KAWARTHA PINE RIDGE DISTRICT SCHOOL BOARD
PUR24-100-ITT
Murray Centennial Public School Addition

ADDENDUM NO. 3

Add (1): Architectural Addendum No. 2, Prepared by Moffet and Duncan Architects Inc. (34 Pages)

1 PARTIAL SITE PLAN
A1.1 1:300

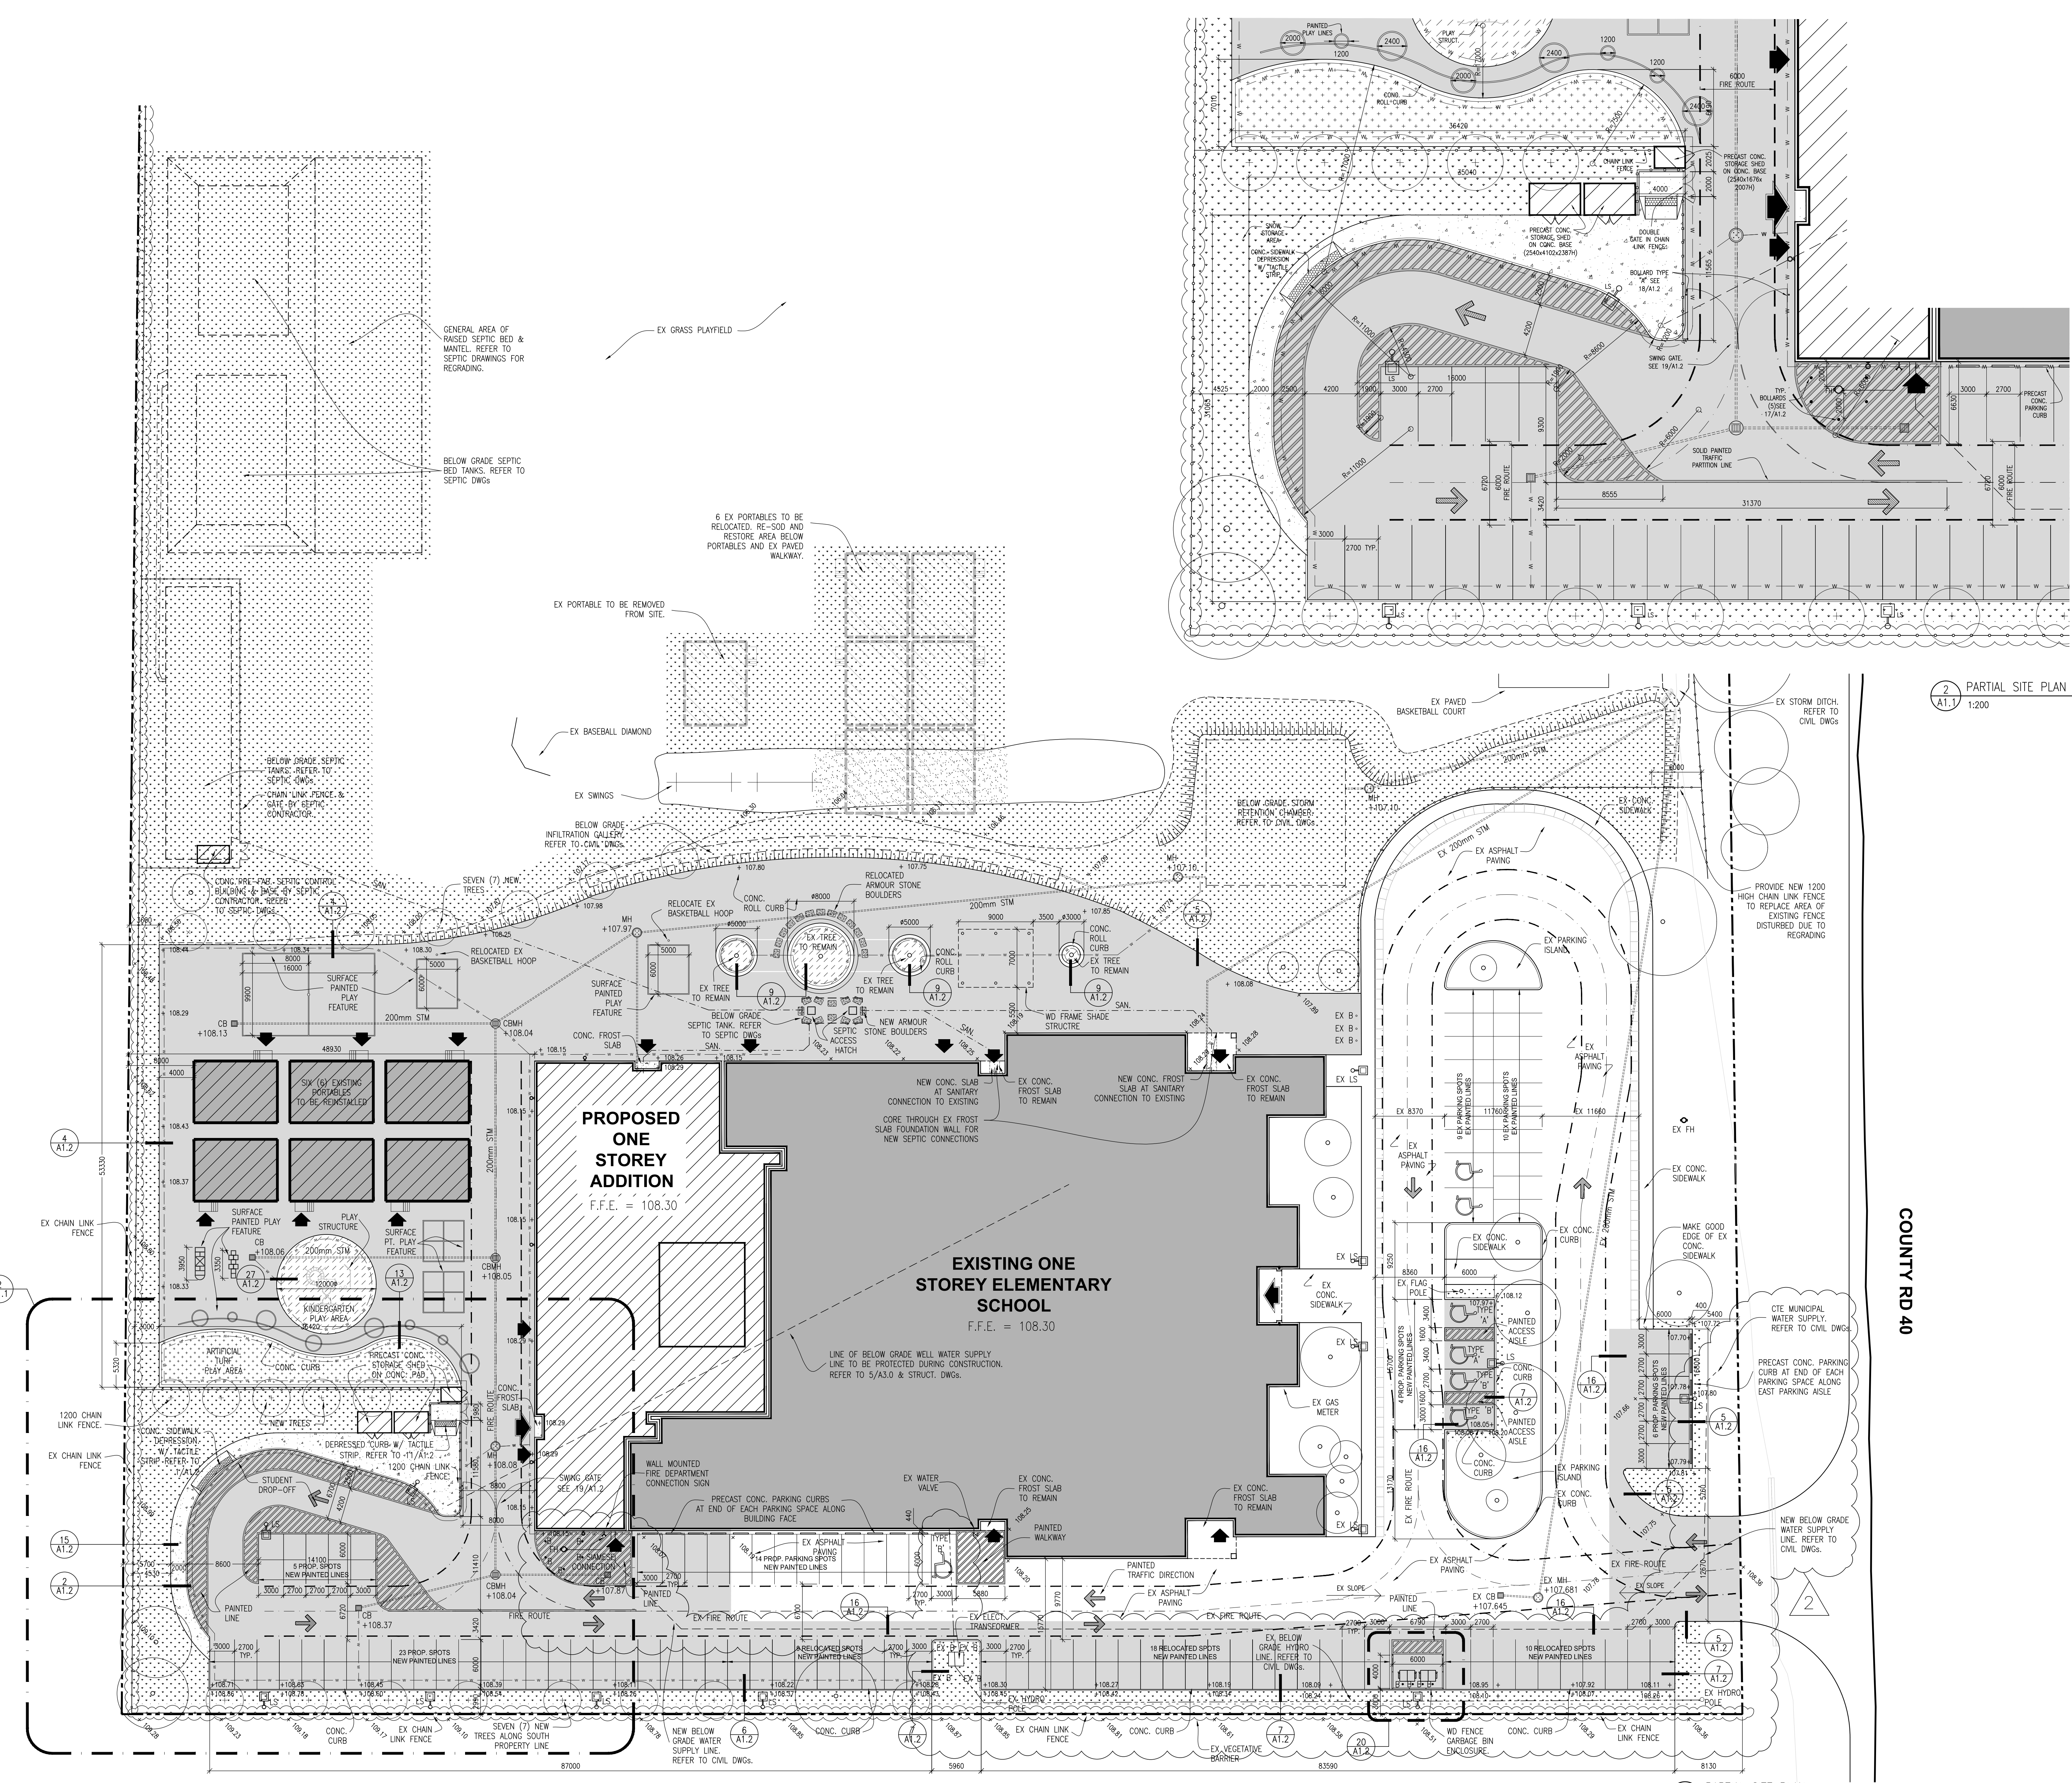
- .1 Replace drawing A1.3 with enclosed Drawing A1.3 Addendum 2.
- .2 Refer to Dwg 1/A1.1 for inclusion of new water supply line and existing below grade hydro line.

DEMO SITE PLAN & SITE PHASING PLAN

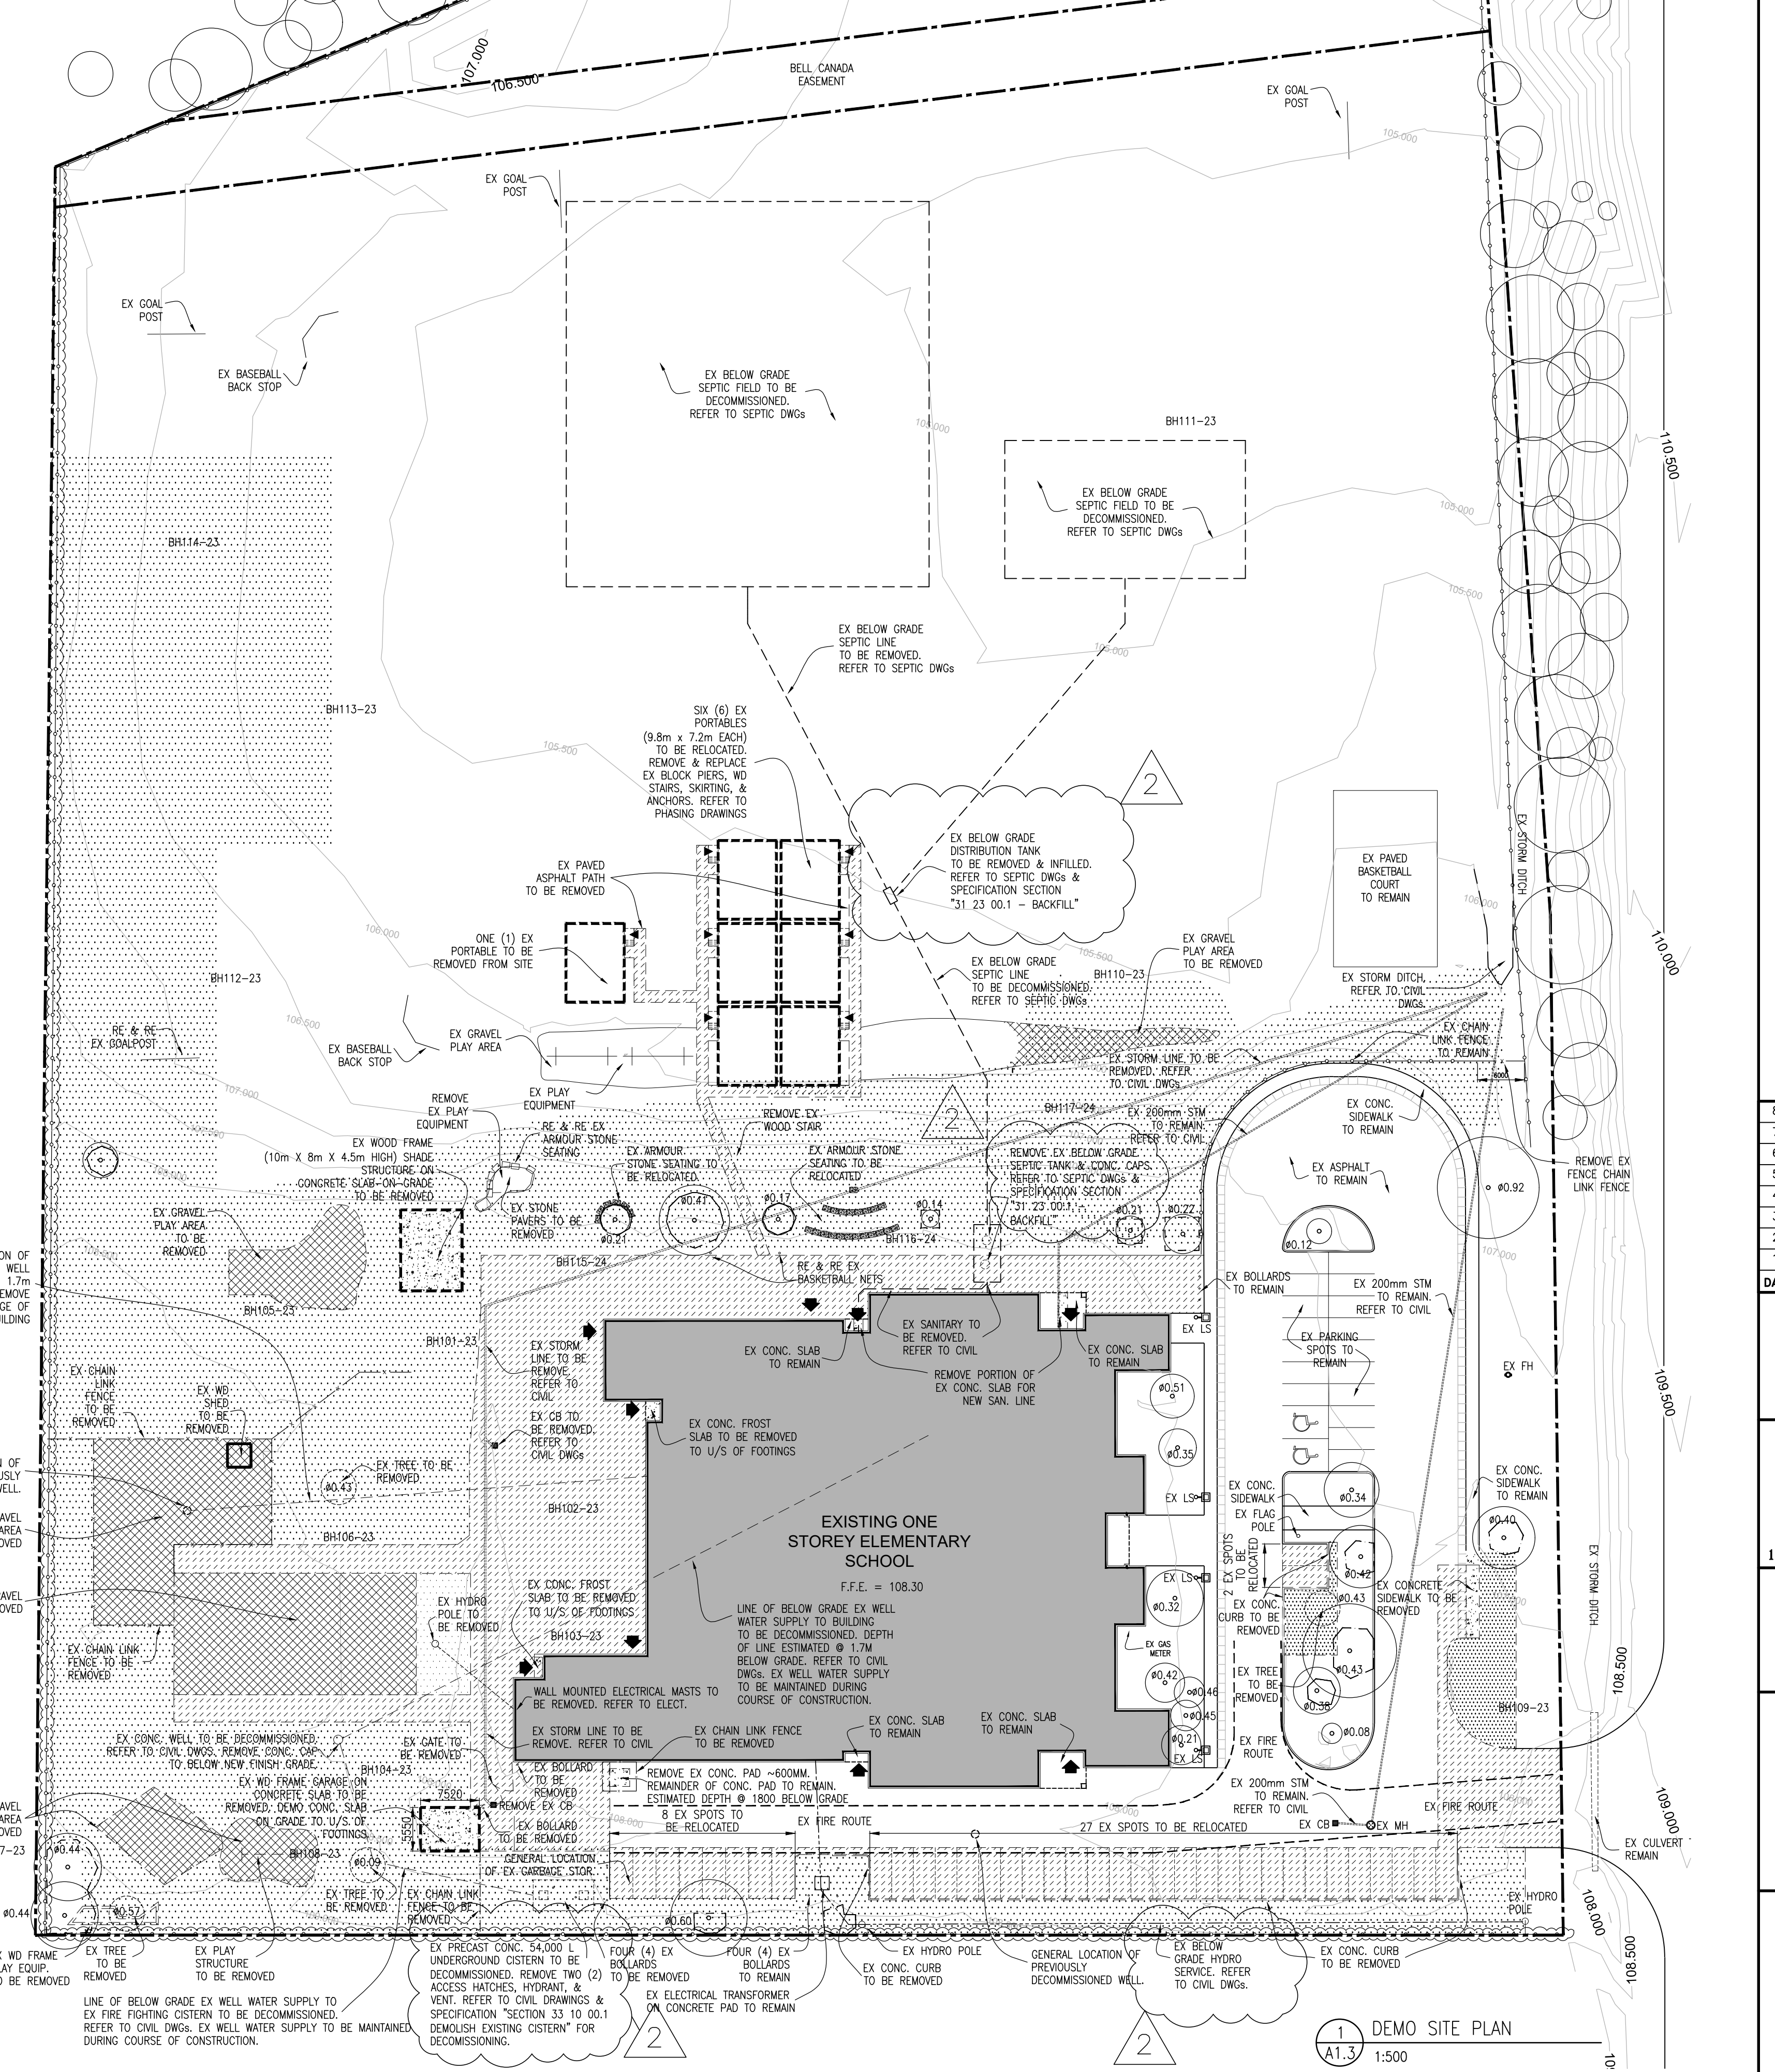
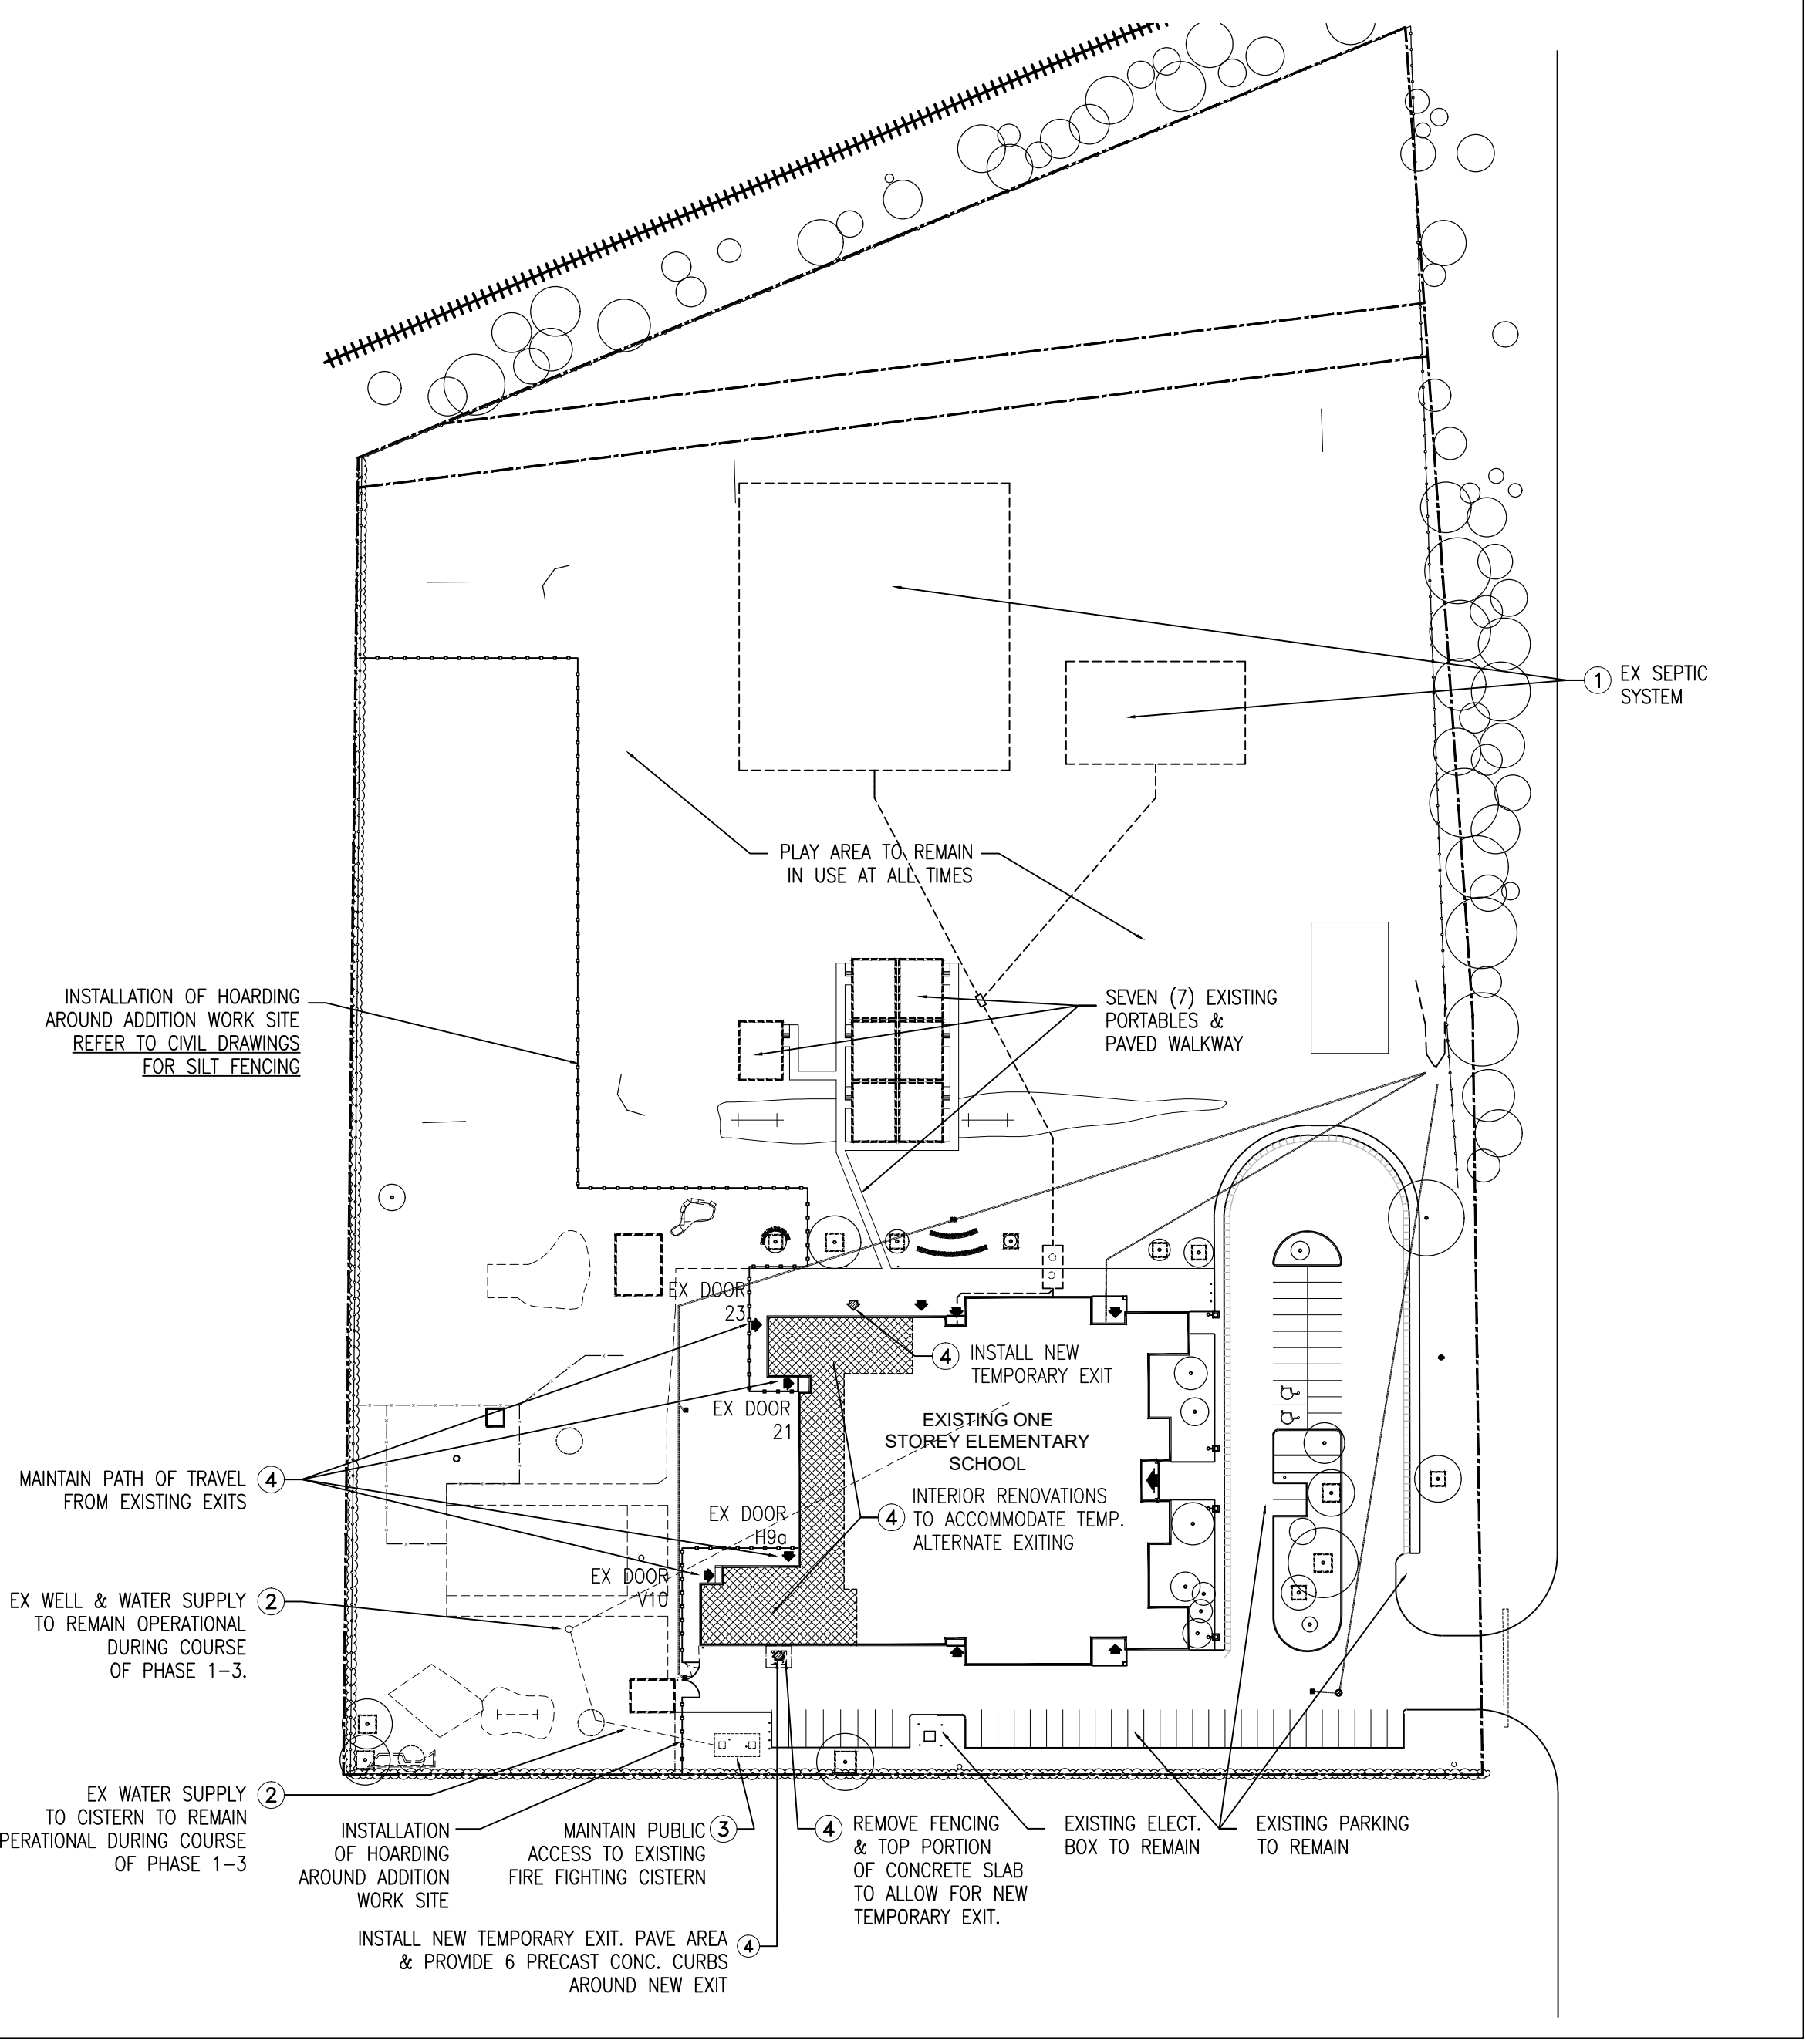
- .1 Replace Drawing A1.3 with enclosed Drawing A1.3 Addendum 2.
- .2 Refer to Dwg 1/A1.3 for revised note to remove and backfill existing septic tank & distribution box.
- .3 Refer to Dwg 1/A1.3 for revised note to decommission ex. fire fighting cistern.
- .4 Refer to Dwg 1/A1.3 for inclusion of existing underground hydro service to remain.
- .5 Refer to Dwg 3/A1.3 for inclusion of "Note 10" and inclusion of new water supply line.
